Surface Mining Permit No. 2015-01
Amendment No. 2 to Reclamation Plan 2006-01A1
City of Lake Elsinore, California

RECIRCULATED PUBLIC REVIEW DRAFT
August 23, 2016

RECIRCULATED DRAFT ENVIRONMENTAL IMPACT REPORT
SCH No. 2006051034

DISTANCES TO SURROUNDING LAND USES

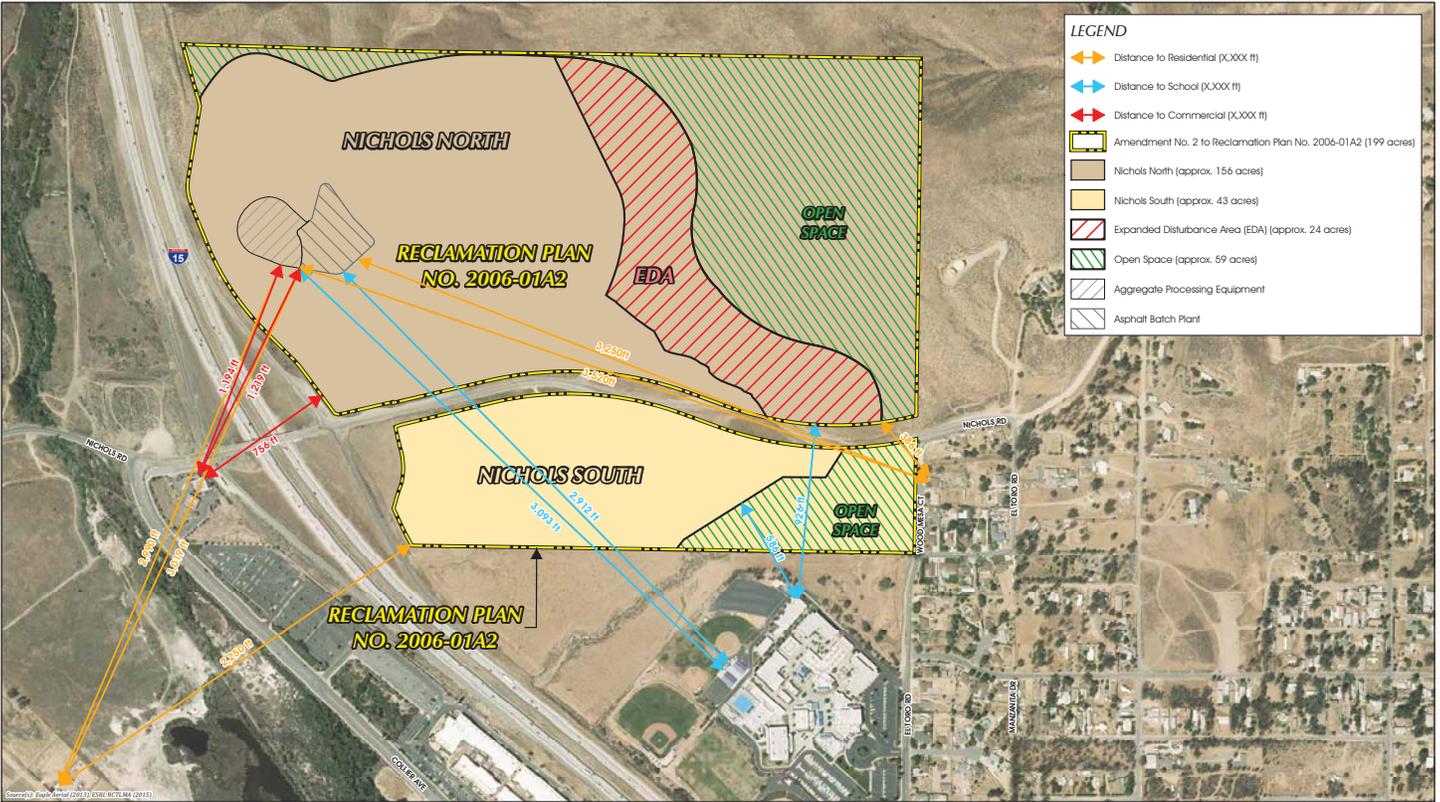
10-9	3	We note you used 1,000 feet as the distance to the High School for your Health Risk Assessment ("HRA") and therefore believe it is invalid as we discuss later.	Please refer to Response 10-8, RDEIR Subsection 3.3.2.D, and Figure 3-6. The revised HRA utilizes a distance of 586 feet, which represents the distance from the nearest portion	Subsection 3.3.2.D

10-58	9	In the Noise section of the DEIR you state that the High School is 610 feet away; in Section 2 you say it is 558 away.	All sections of the RDEIR have been updated to utilize the distances reflected on RDEIR Figure 3-6. Refer also to the discussion presented in RDEIR Subsection 3.3.2.D.	Subsection 3.3.2.D
